TECHNICAL MEMORANDUM

To: Marcus Fuller, City of Palm Springs **Date:** 05/29/2015

From: Michael Adelman, Miko Aivazian, **Reference:** Job No. 10507240
Tyler Hadacek, Jim Borchardt,
Randy Lovan

Subject: Headworks and Primary Clarifier Upgrade Constructability Review
Hydraulic Profile Options and Cost Estimates

Attachment 2
Option 1 Hydraulic Profile Drawing

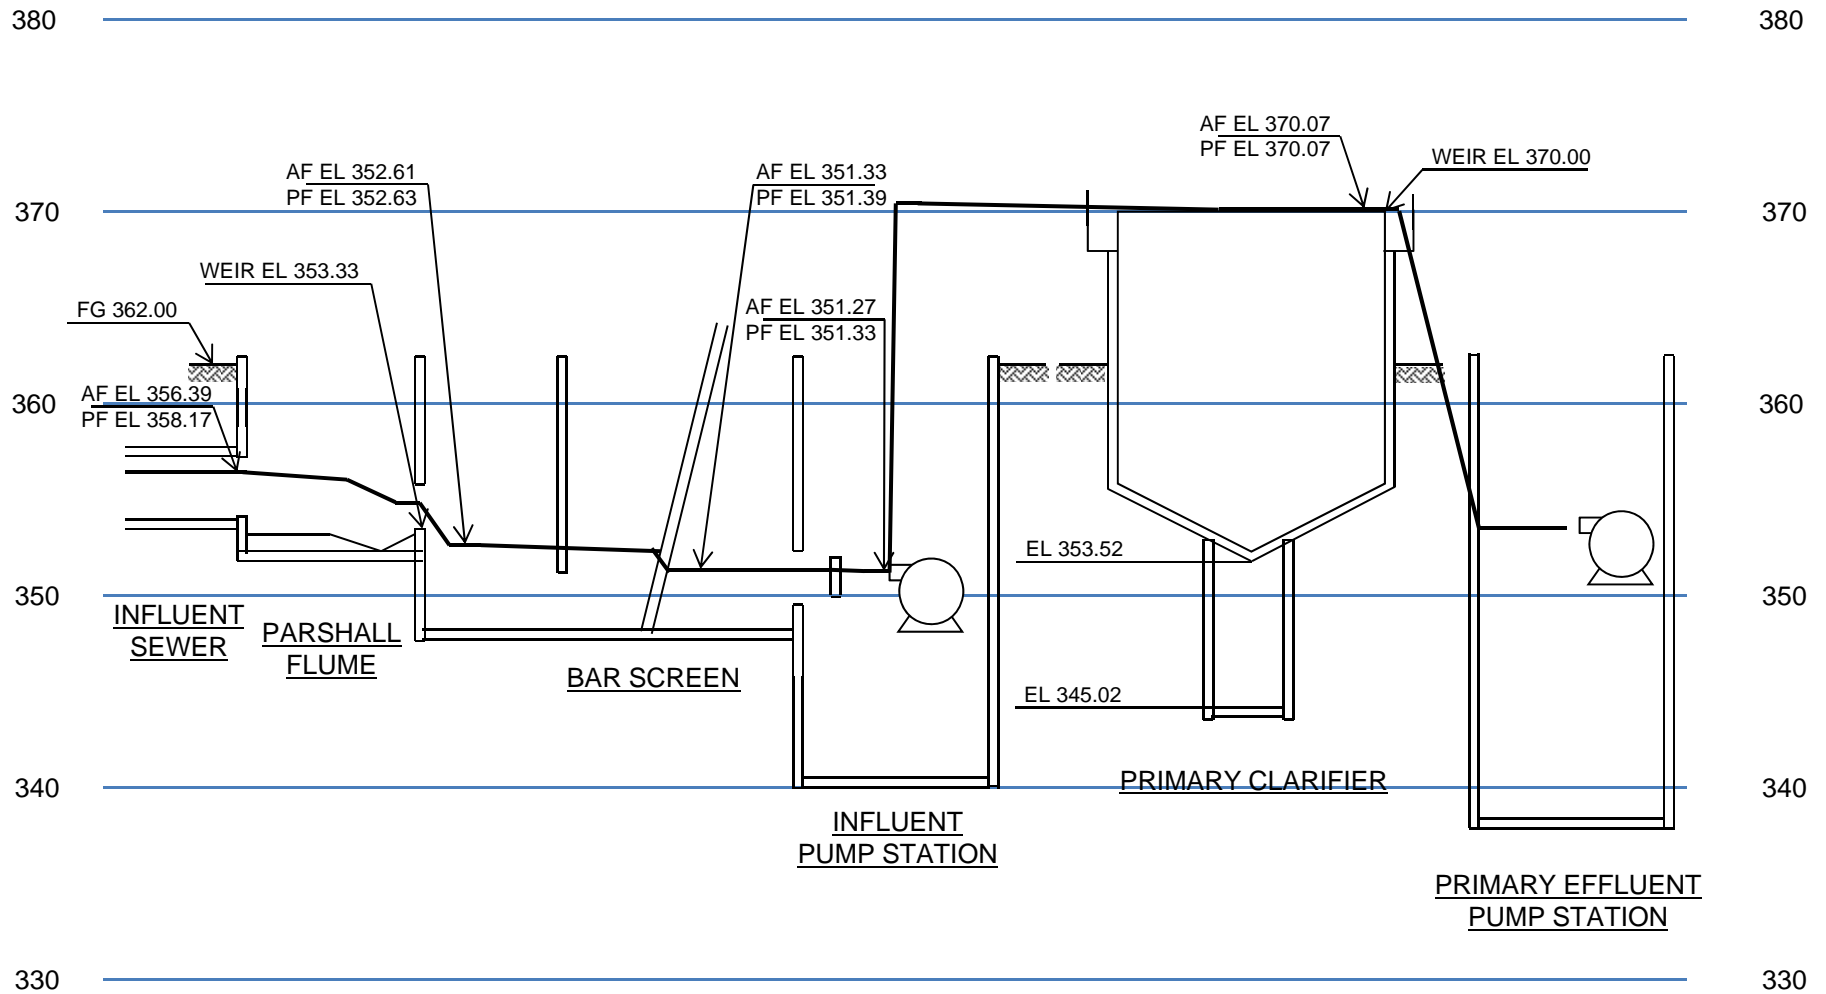
The hydraulic profile associated with Option 1 is tabulated in **Attachment 1** and illustrated in **Attachment 2**. The flowpath in Option 1 includes the elements listed below. Hydraulic grade line (HGL) elevations are reported in feet above mean sea level for the average plant capacity of

1. Water enters the headworks through the **Influent Sewer**, where the HGL elevation at the sewer exit will be about El. 356 ft. This allows for open channel flow in this sewer.

2. Water exits the Influent Sewer into a **Parshall Flume**, which measures the plant flow rate. The headloss across this 24" Parshall Flume will be about 1.6-ft at average flow.

3. From the flume, the water exits over an **Exit Weir** with its crest at El. 353.33 ft. This weir is only 3 ft wide and will have a head loss of about 1.4-ft. This Exit Weir sets the water level in the Influent Sewer, and placing it at the proposed elevation prevents the Influent Sewer from surcharging.

4. After water flows over the Exit Weir, it enters the **Bar Screen Channels**. There are two parallel Bar Screen Channels and one bypass channels, all of which share a common influent box. Each channel has an influent gate and an outlet gate. At the influent end, the water elevation will be around El. 352.5 ft, which allows for some freeboard space below the Exit Weir.

5. The major headloss elements in the Bar Screen Channels are the **Bar Screens**. With one bar screen channel online, the headloss across the screen will be around 1.3-ft, and the water level in the channel downstream will be around El. 351.3 ft.

6. Water exits the Bar Screen Channels into the **Influent Pump Station Wet Well**. There are two wet wells sharing a common influent box, and water passes through a gate and baffle wall to enter each wet well. The operating water surface elevation in the wet well is El. 351.25 ft. The recycle flow also enters here, to be conveyed to the clarifiers.

7. From the wet well, the **Influent Pumps** convey water to the Primary Clarifiers through a 36" pipeline. Assuming one clarifier offline, providing the full plant flow to the farther clarifier (through about 310-ft of pipe) requires the pumps to provide 22-ft of head.

8. Water flows through the 100-ft diameter **Primary Clarifiers**, and exits over the weir with a crest at El. 370 ft. The water depth in the proposed clarifiers is over 16-ft.

Clearly, meeting the design objectives of Option 1 requires the construction of the IPS as designed. The proposed elevation of the clarifier weir indicates that some kind of lift is required for flow to get through the clarifiers, given the much lower HGL elevation in the influent sewer and the requirement to keep this elevation low enough to prevent the sewer from surcharging.

Attachment 5
Option 2-3 Hydraulic Profile Drawing

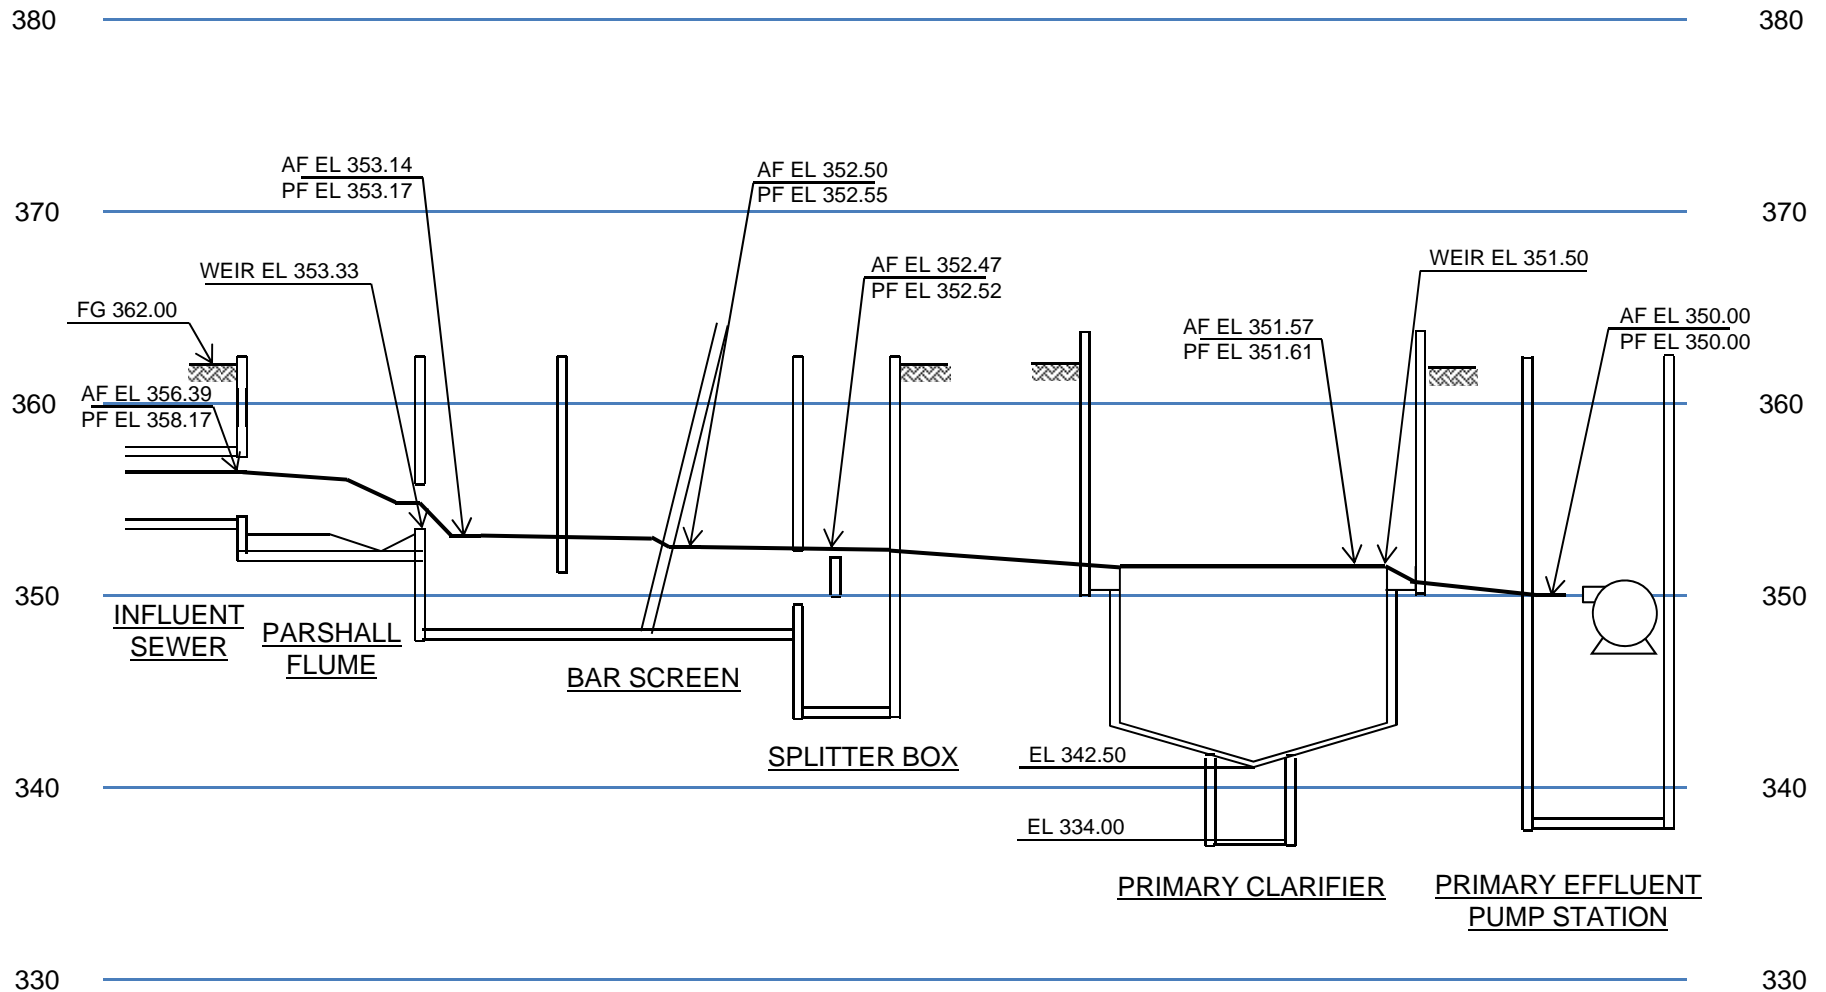
The hydraulic profile associated with Option 2 is tabulated in **Attachment 4** and illustrated in **Attachment 5**. The flowpath for this option, starting from the Bar Screen Channel, is described below. Note that the profile from the Influent Sewer to the Parshall Flume Exit Weir (Steps 1-3) for this option is the same as in Option 1, because these elevations are set by the Exit Weir.

4. After water flows over the Exit Weir, it enters the **Bar Screen Channels**. At the influent end, the water elevation will be around El. 353.1 ft, which just avoids overtopping the Exit Weir.
5. The major headloss elements in the Bar Screen Channels are the **Bar Screens**. With one bar screen channel online, the headloss across the screen will be around 0.6-ft, and the water level in the channel downstream will be around El. 352.5 ft. The headloss through the bar screens is reduced compared to Option 1 because the water in the Bar Screen Channel is deeper, and the velocity through the bar screen is therefore lower.

6. Water exits the Bar Screen Channels into a ***Splitter Box***, which replaces Influent Pump Station Wet Well from Option 1. Flow enters this Splitter Box from the two Bar Screen Channels and the Recycle lines. From the Splitter Box, water flows to the Primary Clarifiers through a 36" pipeline. Assuming one clarifier offline, the headloss through this piping will be approximately 1-ft.

7. Water flows through the ***Primary Clarifiers***, and exits over the clarifier weir with a crest elevation of 351.5 ft. Note that if the clarifier weir were any higher than this elevation, the Exit Weir of the Parshall Flume would be overtopped, backing up the water in the Influent Sewer. The clarifiers in this option are proposed to be 9-ft deep.

8. From the Primary Clarifiers, water must flow to the existing ***Primary Effluent Pump Station Wet Well*** by gravity. The flowpath to the PEPS consists of 42", 36", and 48" piping, with a total headloss around 0.7-ft at average flow. The current operating water level in this wet well is between El. 352 and El. 354.5 ft, and this level must be reduced to around El. 350 ft to avoid overtopping of the primary clarifier weirs.

The hydraulic profile associated with Option 3 is tabulated in **Attachment 4**, along with the Option 2 hydraulic profile. The flowpath and associated HGL elevations are the same for this option as in Option 2, except that the piping to and from the Primary Clarifier is upsized to 48". This larger pipe prevents water from overtopping the Parshall Flume Exit Weir and the Primary Clarifier Weir at peak flow.

Attachment 7
Option 3 Site Layout

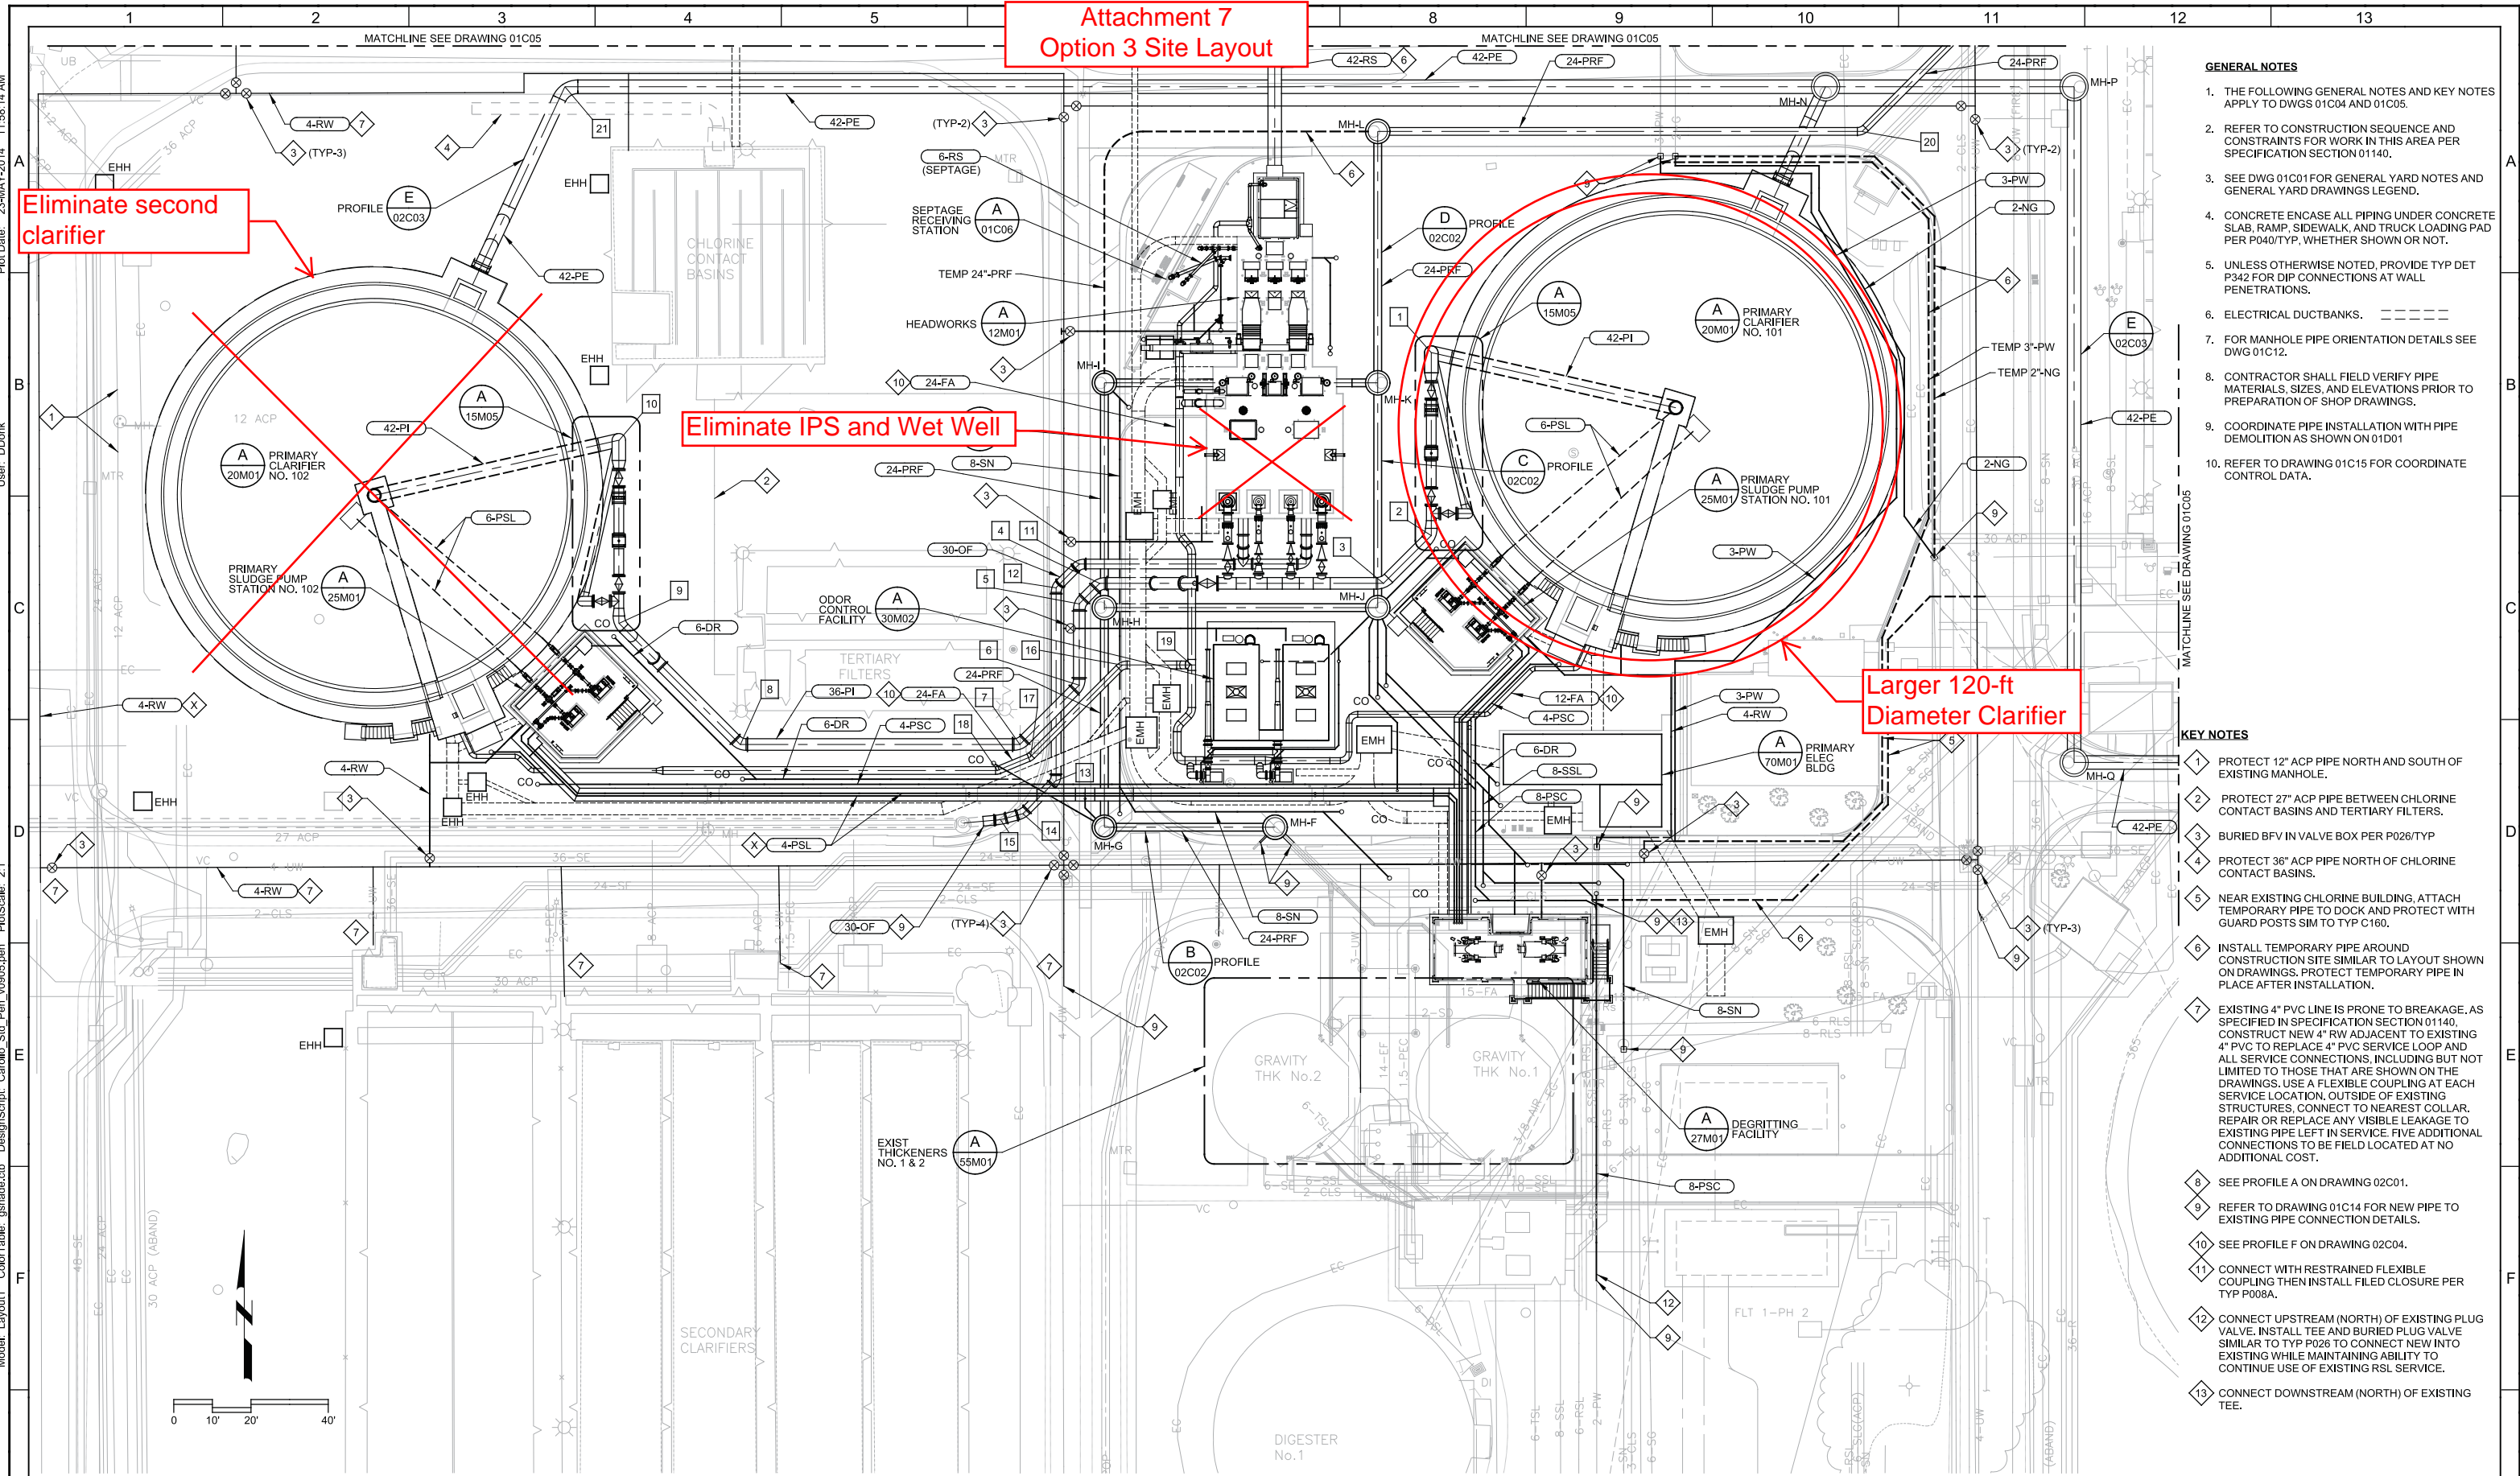
This option would allow for significant reduction in construction cost. In addition to the savings from eliminating the IPS (as in Option 2), this option significantly reduces the cost of earthwork, shoring, concrete work, and mechanical equipment by eliminating one clarifier. Savings would be realized even with larger 48" diameter yard piping. The footprint of the headworks and primary treatment would also be substantially reduced (**Attachment 7**).
